VILLAGE OF MONROE

Workshop

August 10, 2026

Village of Monroe Planning Board Review

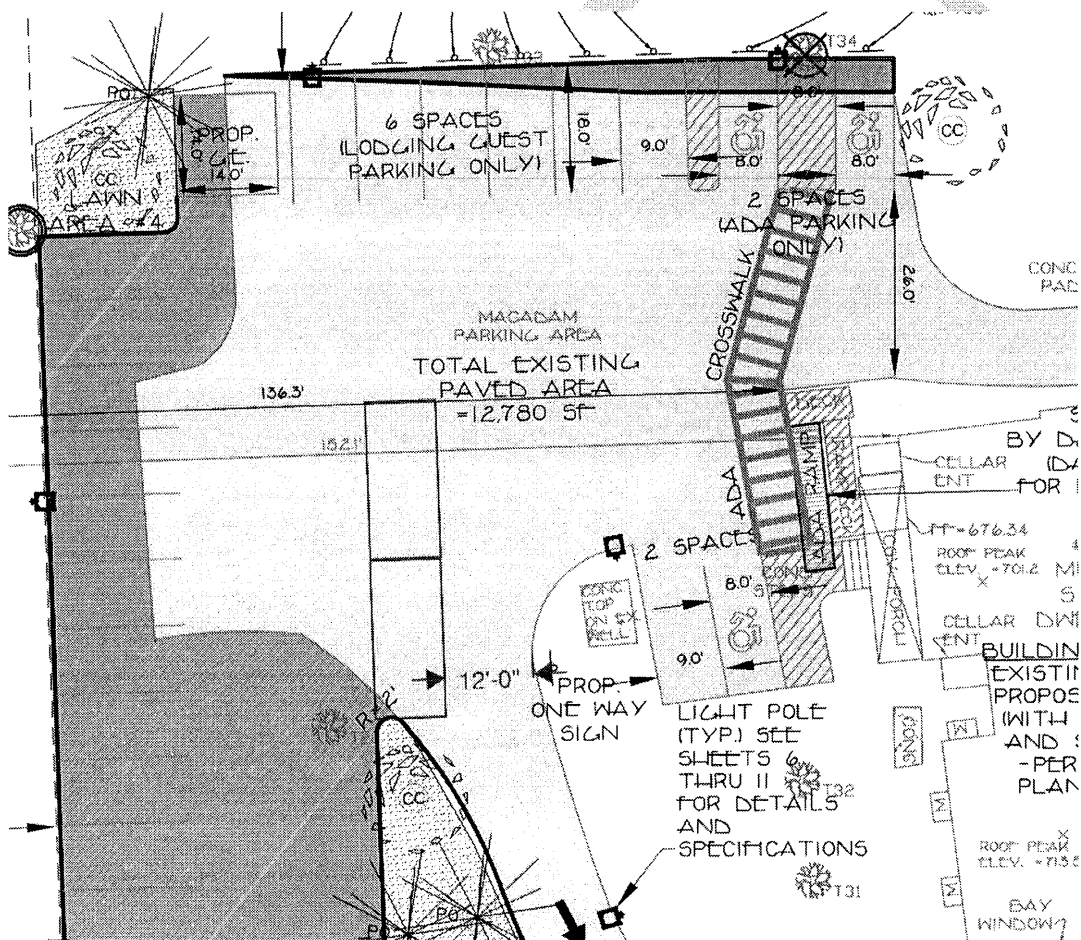
The Applicant has provided a parking layout indicating that 54 parking spaces will be provided (including 3 ADA spaces). Based on a review of the Site Plan provided, it appears that two additional Code-complaint parking spaces could be added (see below), bringing the total number of parking spaces provided to 56. Based on a review of a fire truck turning template, it appears that the two additional parking spaces will not prevent a fire apparatus from entering the property, maneuvering to turn around and drive out. It is recommended that the Applicant consult with the Fire Department if it is intended to add these two parking spaces.

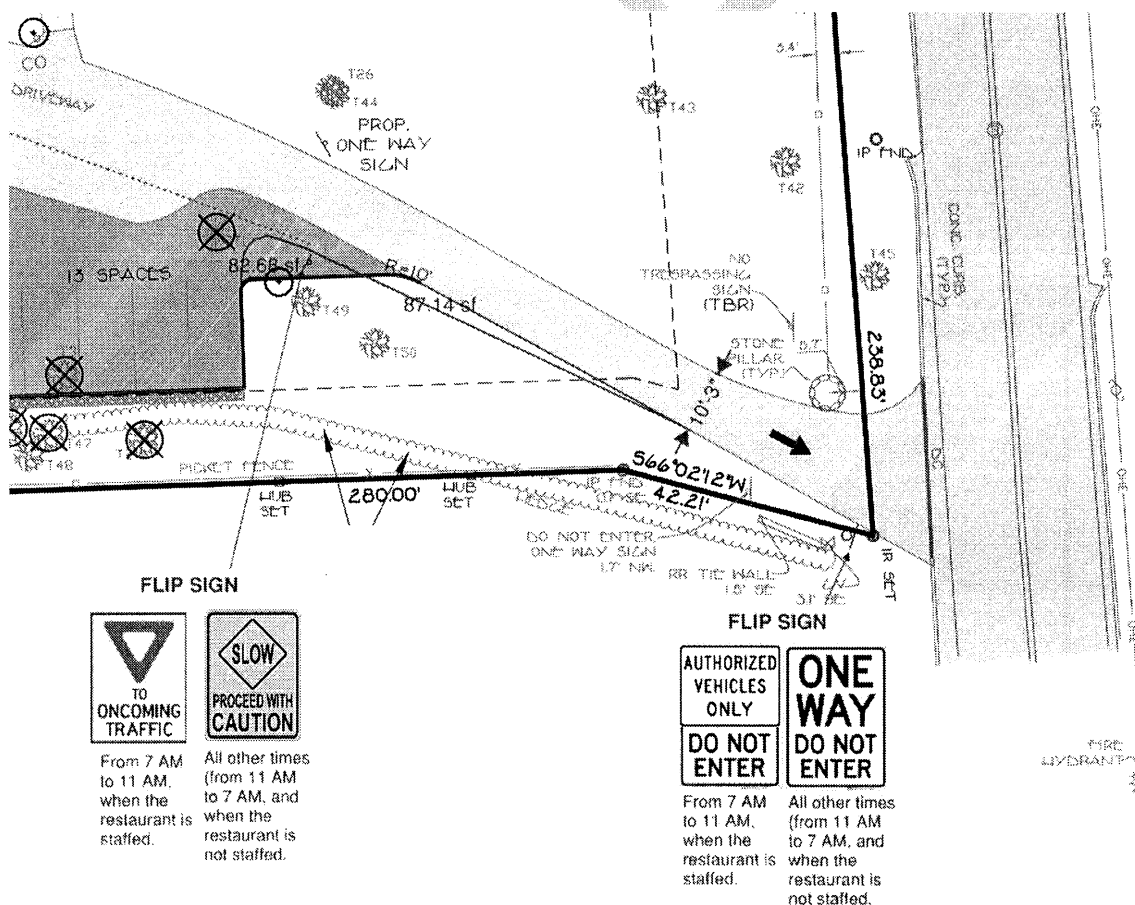
Ingress to the facility will be provided from an existing driveway at the north end of the property on High Street. This entrance driveway passes under an existing car port, which is historic, cannot be changed and has a clearance of 9 feet. Egress to High Street will be provided via an existing driveway at the south end of the property. Because of the limited clearance over the car port, it will be necessary for all trucks visiting the site to enter and exit via the south driveway and, because of the driveway's configuration, to arrive at the site from the south on High Street, turning left in, and to depart the site to the south, turning right out. The south driveway is only 110.25-feet wide where it passes to the south of a historic gateway pillar which cannot be moved or modified.

For the south driveway to safely accommodate project traffic, it will be necessary to limit incoming traffic at the south driveway to periods when there is little or not exiting traffic at the Site and to advise any motorist who might happen to be exiting when a vehicle might be entering of the need to yield right of way. It is proposed to accommodate this by installing two Flip Signs at either end of the driveway (and by widening the driveway slightly to better accommodate arriving and departing vehicles as indicated below. Both flip signs would have the ability to be locked in one of two positions, as described below.

The Flip Sign posted at the lower end of the south drive would face entering traffic and rest with the message "ONE WAY, DO NOT ENTER". This would prohibit all but emergency vehicles (with lights and sirens activated) from entering the driveway for all but a limited time period. Trucks servicing the facility (food, beverages, trash removal, etc.) would be prohibited from visiting the facility except during very specific times when the restaurant was closed and there was very little traffic activity at the site.

Based on the assumption that the restaurant will not be serving breakfast, it is recommended that trucks only be permitted to enter the site between 7:00 a.m. and 11:00 a.m. The Board may wish to discuss these hours with the Applicant to better refine them. Every day that the restaurant is open and deliveries might occur, a restaurant staff member (or the caretaker) will go down to the sign at 7:00 a.m., unlock it, flip it over to the second message, which shall read "AUTHORIZED VEHICLES ONLY, DO NOT ENTER", and relock the sign in this position. Only trucks visiting the site for business purposes will be authorized to enter the site at this location and only during the approved hours. At 11 a.m. the restaurant staff member or care taker will return to the sign, restore it to the at-rest position and relock it.

The Flip Sign posted at the at the upper end of the south drive would face exiting traffic and rest with the message "SLOW, PROCEED WITH CAUTION". This would simply advise exiting motorists to use due caution when exiting the site. Every day that the restaurant is open and deliveries might occur, a restaurant staff member (or the caretaker), when they go to the lower signs, will also go to this upper sign (at 7:00 a.m.), unlock it, flip it over to the second message, which shall read "YIELD TO ONCOMING TRAFFIC", and relock the sign in this position. This sign will advise any exiting motorist that, if they encounter an entering vehicle, they must stop and allow it to pass.

Day 90

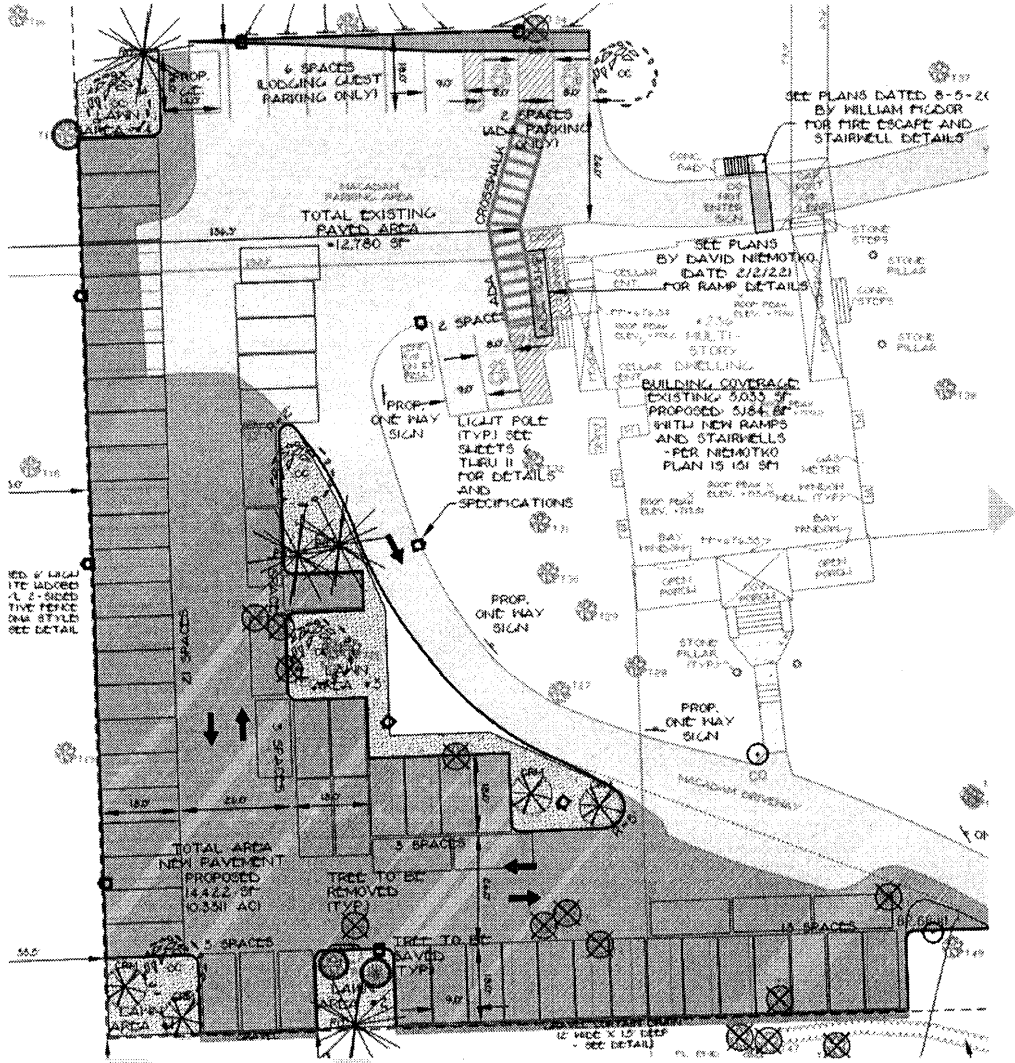
5. In addition, three-months after opening, the Planning Board may also consider whether the Applicant could employ valet parking at peak times to increase the number of vehicles that can be parked on the property. Based on a review of the Site Plan, as shown below, it is believed that a professional valet operator would be able to increase the number of vehicles parked on the site from 54/56 to 74. This would potentially allow the number of seats to be increased to 150 for an average-performing restaurant or to 113 for a successful restaurant.

A truck turning analyses was performed for a fire apparatus and it was determined that a fire truck would be able to enter, turn around and exit with parking laid out as shown above. However, before valet parking could/should be permitted, the Fire Department would have to be consulted to determine whether the proposed layout would actually accommodate the necessary fire apparatus. Once the new parking lot is built, it would be relatively easy for the Fire Department to place cones strategically in the parking lot to simulate the position of the cars and to see if their vehicles could adequately negotiate the parking lot.

Assuming that the Fire Department had no objection, it is recommended that the Applicant be permitted to submit a parking study in support of a request to the Building Inspector to increase
